REVIEW OF PERMIT APPLICATION RMU-2, CWM MODEL CITY

**Anirban De, Ph.D., P.E.
Professional Engineer
New York License No. 080871**

Project Number: 1303
15 October 2014

(“Thickness of Glaciolacustrine Silt/Sand”
included as Figure 8 of the 2013 Hydrogeologic Characterization Update)

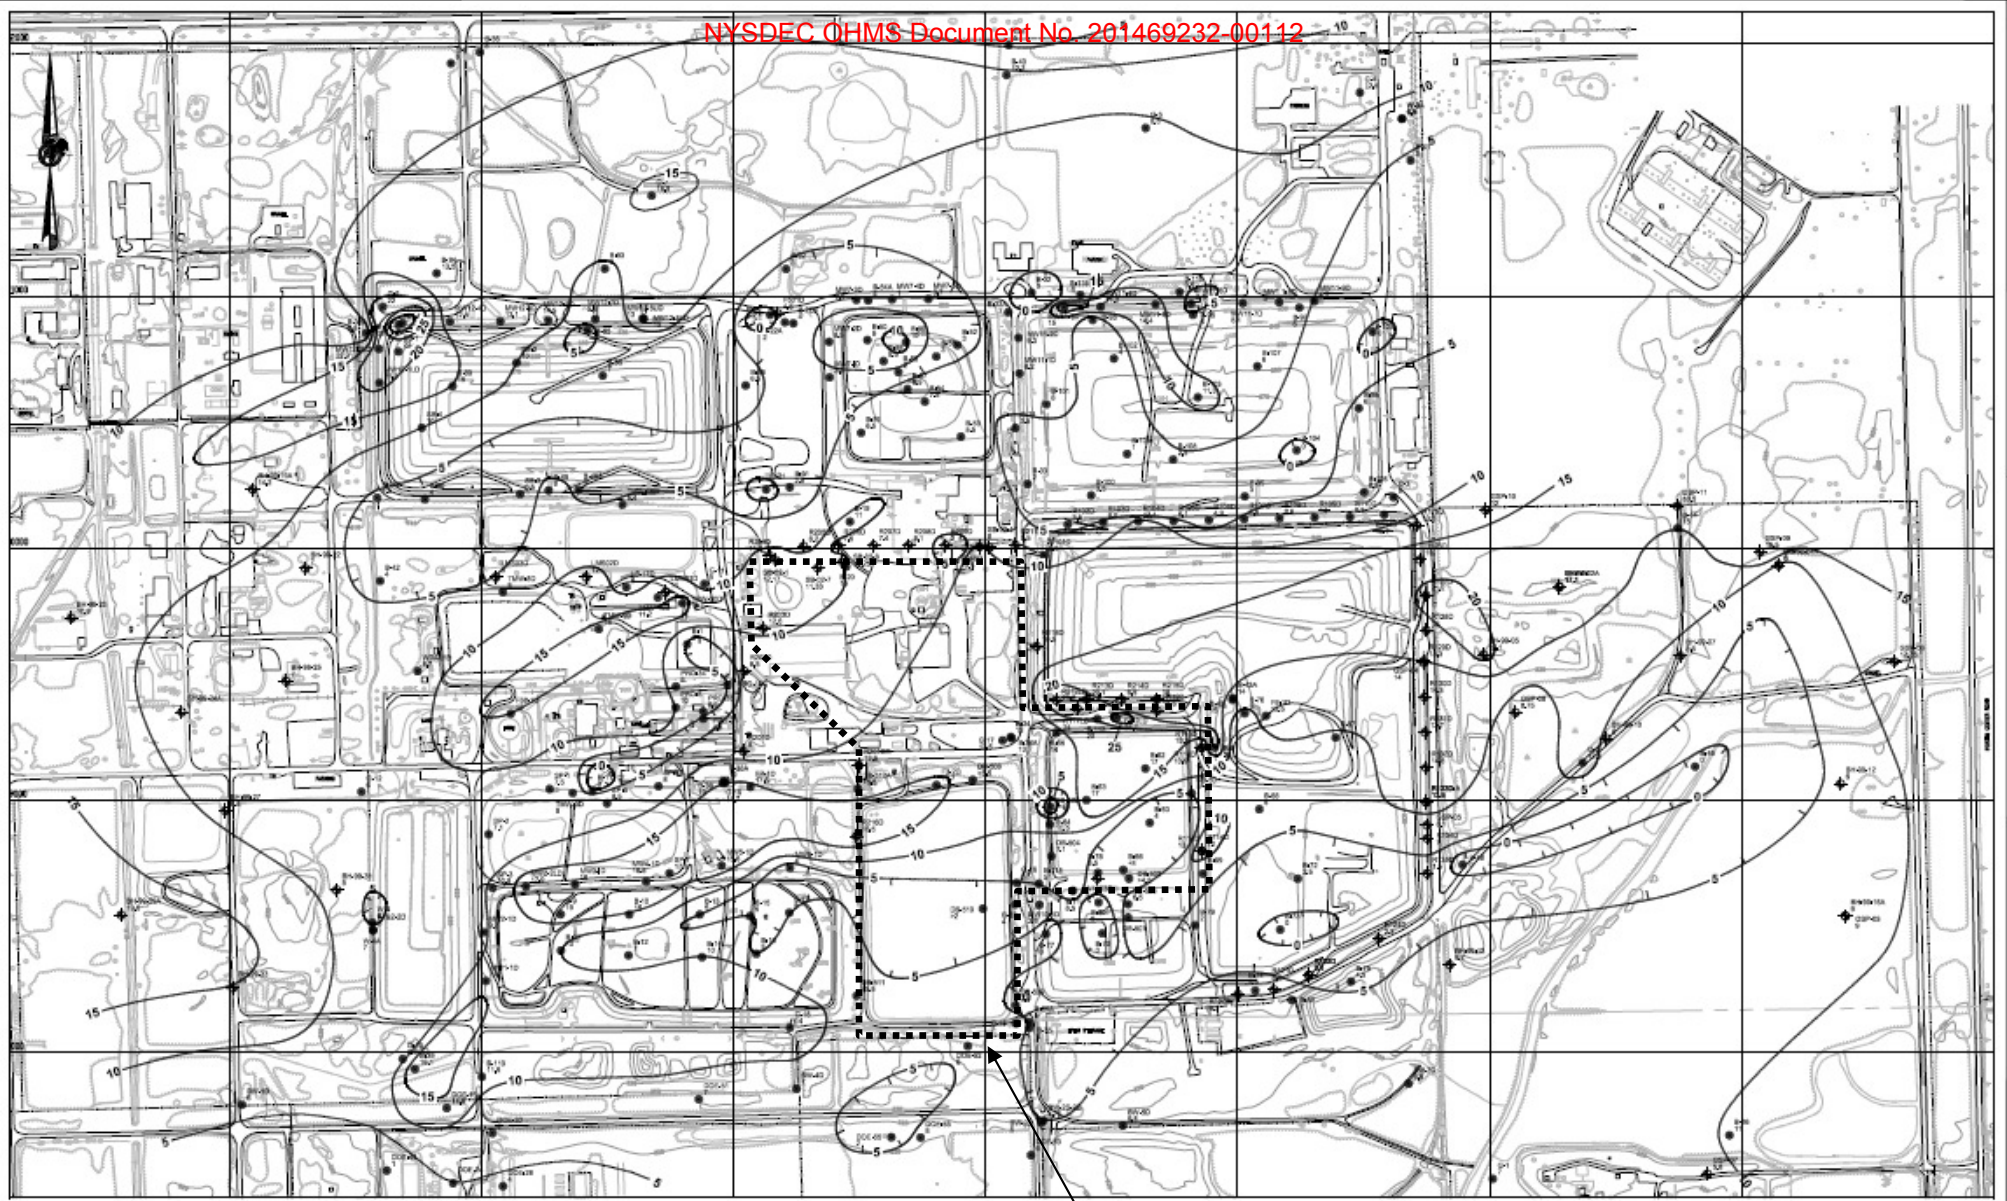
Attachment 1 of Appendix A-1 presents the “Thickness Contours of Glaciolacustrine Silt/Sand Unit” (Exhibit E). According to this drawing, the thickness of the GSS unit varies from 25 feet to less than 5 feet within the footprint of the proposed RMU-2 landfill. Thickness contours shown in Exhibit E are not consistent with those from a more recent drawing by Golder Associates (Hydrogeologic Characterization Update, 2014), included here as Exhibit F.

A review of Exhibits E and F indicates a general lack of borings under the proposed RMU-2 footprint. There are only a few contour lines through the footprint area, connecting points that are very far apart. This is especially true for the western portion of the site. Thus, the applicant has relied on borings outside the RMU-2 footprint and interpolation over large distances to calculate presumed thickness of the GSS unit.

The applicant must conduct a thorough soil boring program covering the footprint of RMU-2 to establish the hydraulic conductivity and thickness at different locations of the GSS unit, without having to rely on large-scale interpolation. Based on the results, the applicant may consider an underdrain system specifically engineered to dissipate excess pore water pressure during consolidation. In that event, the applicant must take into account the possible impacts of such an underdrain on the localized hydrologic conditions at the site.
